Model: M-G1L	Date: 12-Feb-10	No.: RJ021001f
--------------	-----------------	----------------

Subject: Firmware Release Note: Engine/Controller		Prepared by: Y. Gaman	
From: 1st Tech Service Sect., MFP/Printer Tech Service Dept.			
Classification:	<input type="checkbox"/> Troubleshooting	<input type="checkbox"/> Part information	<input type="checkbox"/> Action required
	<input type="checkbox"/> Mechanical	<input type="checkbox"/> Electrical	<input type="checkbox"/> Service manual revision
	<input type="checkbox"/> Paper path	<input type="checkbox"/> Transmit/receive	<input type="checkbox"/> Retrofit information
	<input type="checkbox"/> Product Safety	<input checked="" type="checkbox"/> Other (Firmware)	<input checked="" type="checkbox"/> Tier 2

Subject: Countermeasure for the left cover whitening		Prepared by: K. Nakano	
From: 2nd Overseas Tech Support Sec., 2nd PQM Dept.			
Classification:	<input type="checkbox"/> Troubleshooting <input type="checkbox"/> Mechanical <input type="checkbox"/> Paper path <input type="checkbox"/> Product Safety	<input checked="" type="checkbox"/> Part information <input type="checkbox"/> Electrical <input type="checkbox"/> Transmit/receive <input ty

BRACKET: PCB: CONTROL

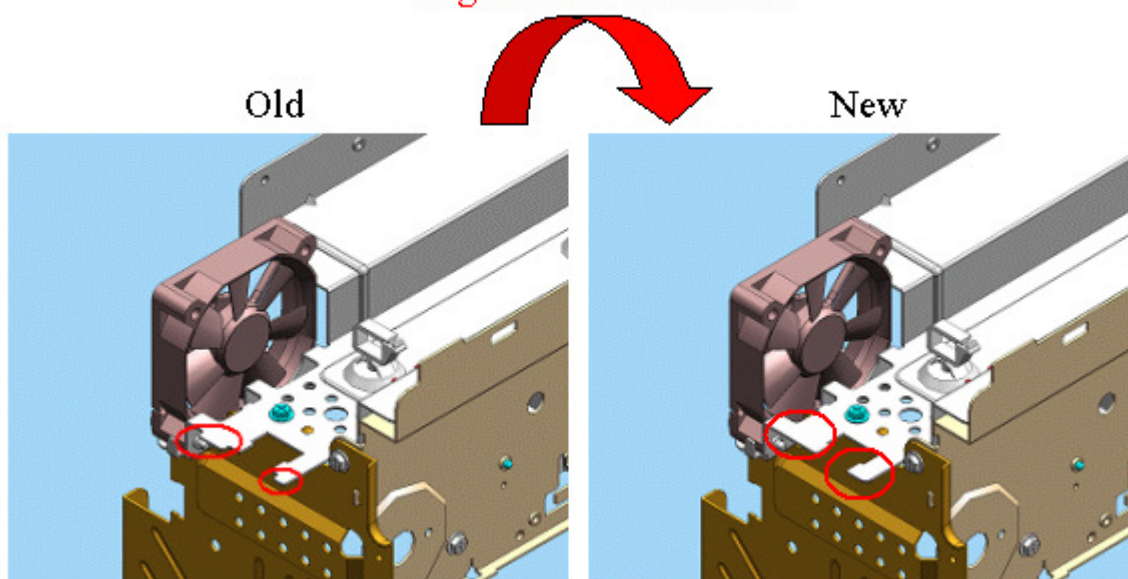
- 1) The shape of the left cover was changed.
- 2) The bracket for the PCB was added as a service part.

**Note:** The shape of the bracket was changed as shown in the illustration.

The small tabs on the tip of the bracket were removed.

**Slight tabs are removed**

**Reason:** To provide further protection against shock and vibration during product shipping.

COVER: LEFT: EU

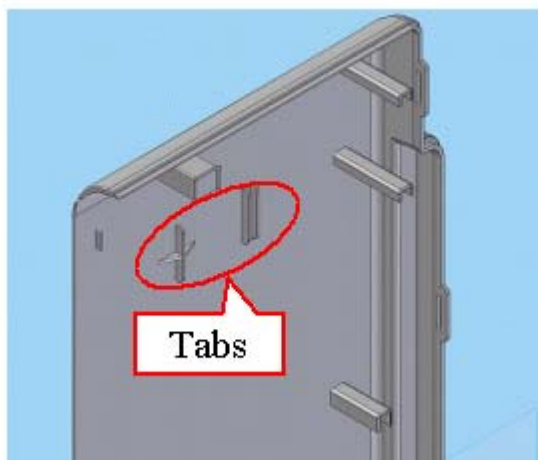
Tabs were added.

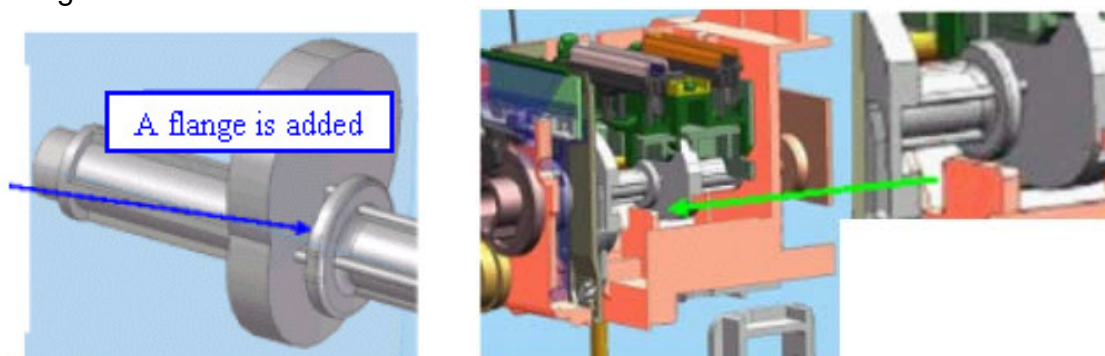
A flange was added to the cam on the maintenance unit.

Old Part #	New Part #	Description	Int.	Q'ty
J0170412	J0170413	MAINTENANCE RECOVERY (for J017/J019)	X/O	1

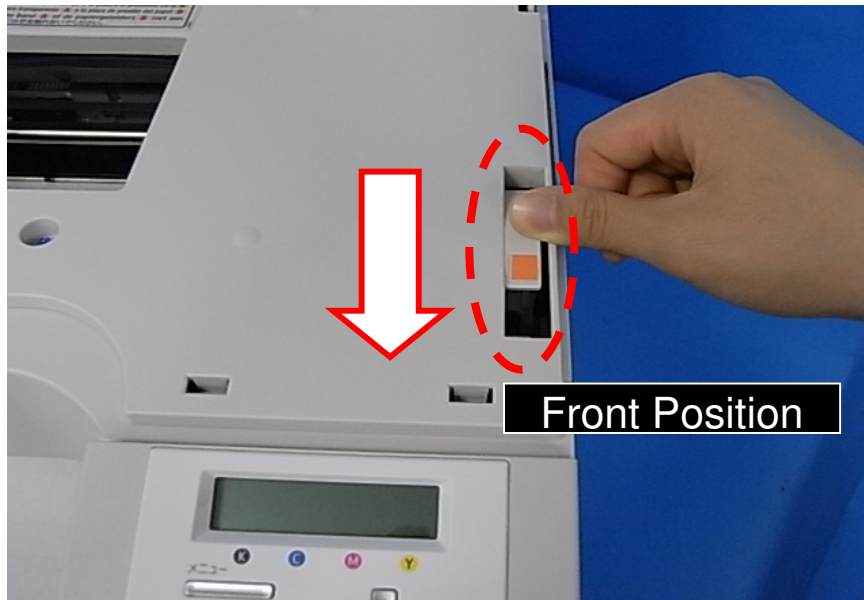
The carriage position lever is mistakenly set to the envelope position (rear position), which raises the carriage unit. A gap develops between the print heads and caps on the maintenance unit. As a result, the machine cannot properly perform ink suction (which causes the SC) or head cleaning (which causes the white lines).

1. Please remind users not to move the carriage position lever to the envelope position when performing ink initialization. Also, remind them that the lever should be set to the front position except when printing onto envelopes.

2. For users that print onto envelopes only, replace the maintenance unit.

#### 1. Cassette tray:

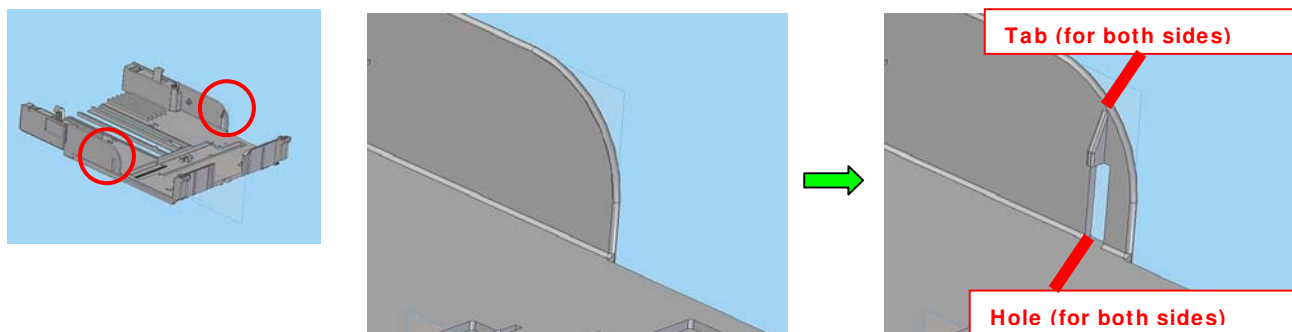
Tabs and holes were added to the left and right sides of the tray. This is to prevent the base plate from hitting the left arm.

Old Part #	New Part #	Description	Int.	Q'ty	Note
J0173034	J0170034	CASSETTE TRAY	X/O	1

## 2. Left side fence:

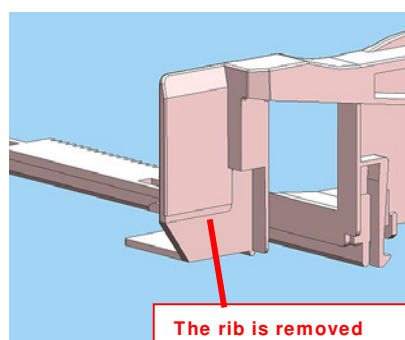
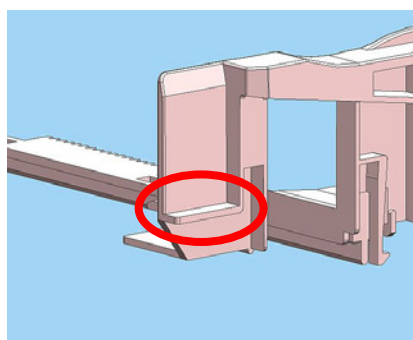
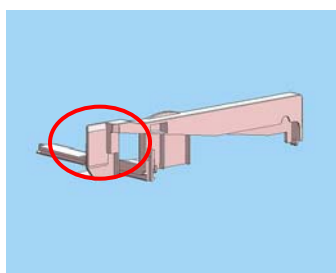
The rib was removed so that the left arm will not hit the trailing edge sensor even if the tray is set with the left arm incorrectly attached.

Old Part #	New Part #	Description	Int.	Q'ty	Note
J0173004	J0173007	SIDE FENCE: LEFT: A4	X/O	1

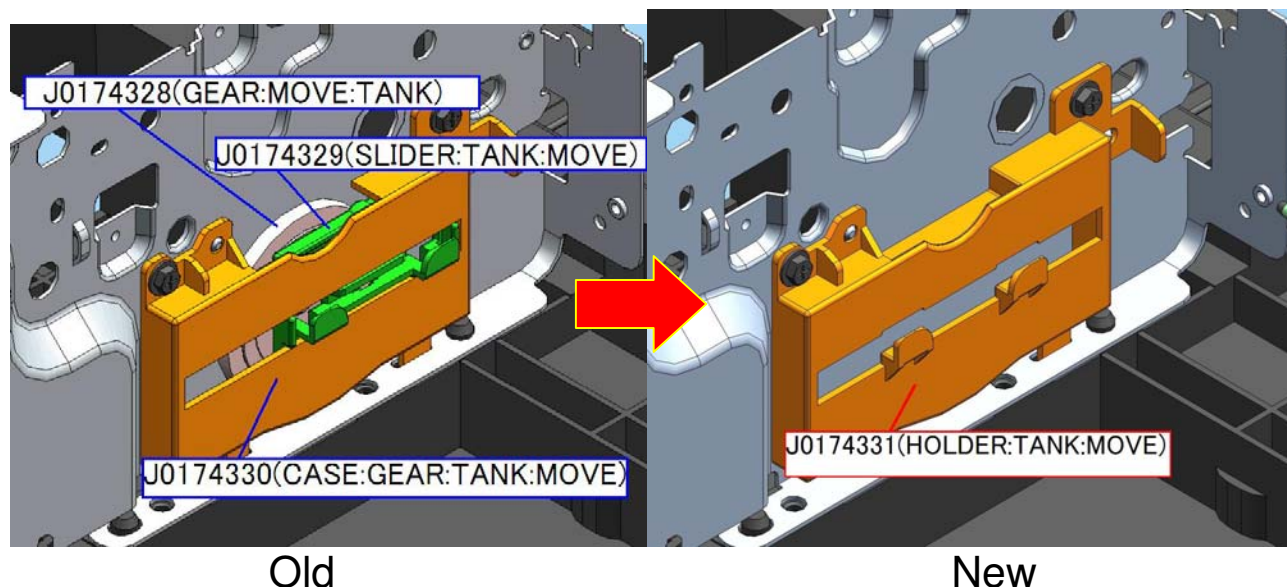
- 1) The gear and slider were deleted.
- 2) The shape of the case was changed.

**Important:** When you install the new holder (J0174331) for the first time, make sure to remove the gear (J0174328) and the slider (J0174329).
